STAFF REPORT

Case No. ARB2104-01

SUBJECT: Discuss and consider an application for a Landscape Architectural Waiver Request to reduce the minimum tree planting requirements for a multi-family development pursuant to Subchapter 11 Table 11.3 C, of the Unified Development Code for the 19365 Wilke Lane multi-family project. (ARB2104-01).

Exhibit B: 1:300

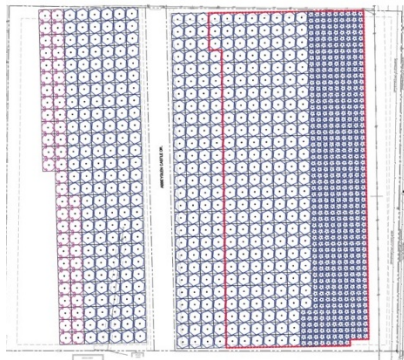
- **Exhibit A:** Intended to depict the required landscape area of 40% and the 1 tree per 300 sf ratio on the lot. The result is a requirement of 939 landscape trees and 52 buffer trees. The larger trees in this scenario (Type A/B) are proposed as the minimum 3" caliper, while the smaller ornamental trees are proposed to be increased in size from the minimum 2" caliper to 3" caliper.
- **Exhibit B:** Further illustrates the code requirement when planted at the recommended spacing established by the Tree Technical Manual found in the Unified Development Code. Trees are not required to be planted at this spacing but is a recommendation to ensure adequate space for maturity. The larger trees in this scenario (Type A/B) are proposed as the minimum 3" caliper, while the smaller ornamental trees are proposed to be increased in size from the minimum 2" caliper to 3" caliper.

Landscape Area: 281,614 sf
 Landscape Trees: 939 landscape trees
 Bufferyard Trees: 52 buffer trees
 Eventual Canopy Coverage: 198% of landscape area

Exhibit C: 1:600

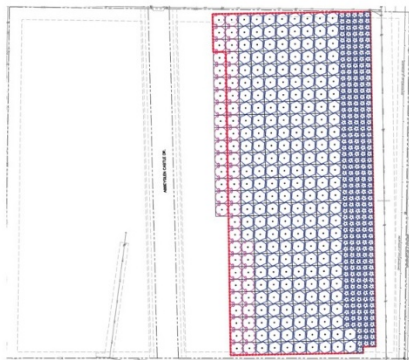
- **Exhibit C:** Illustrates the required landscape area of 40%, the 1 tree per 600 sf ratio, and the generally recommended spacing established by the Tree Technical Manual found in the Unified Development Code. The result is a requirement of 469 landscape trees and 52 buffer trees. The larger trees in this scenario (Type A/B) are proposed as the minimum 3" caliper, while the smaller ornamental trees are proposed to be increased in size from the minimum 2" caliper to 3" caliper.

Landscape Area: 281,614 sf
 Landscape Trees: 469 landscape trees
 Bufferyard Trees: 52 buffer trees
 Eventual Canopy Coverage: 104% of landscape area

Exhibit D: 1:600 w/reductions

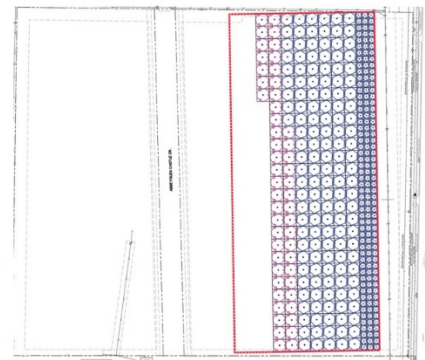
- **Exhibit D:** The proposed request which has been identified by the applicant as a realistic number of trees to be provided on-site. The proposed request includes an administrative 20% reduction in the required landscape area, a 20% administrative reduction in the number of trees, and a proposed ratio of 1 tree per 600 sf of landscape area. The result is a requirement of 375 landscape trees and 52 buffer trees. The larger trees in this scenario (Type A/B) are proposed to be increased from the minimum 3" caliper to 4" caliper, while the smaller ornamental trees are proposed at the minimum 2" caliper.
- **Exhibit E:** Represents the same calculation and quantity as Exhibit D but depicts the proposed trees in the site configuration with the buildings and parking area.

Landscape Area: 225,291 sf (20% reduction)
 Landscape Trees: 375 (20% reduction as fee in lieu)
 Bufferyard Trees: 52 buffer trees
 Eventual Canopy Coverage: 76% of landscape area

The proposed reduction from the 1:300 to 1:600 ratio with the administrative alternative compliance in place provides an opportunity for trees to be provided on-site without impacting the buildable area. Per the tree coverage percentage provided by the applicant on each exhibit, the proposed request will allow the site at maturity to have a tree cover percentage of 76% of the total landscape area, enabling other use of the landscape area besides tree coverage. Staff continues to recommend support for the proposed request.
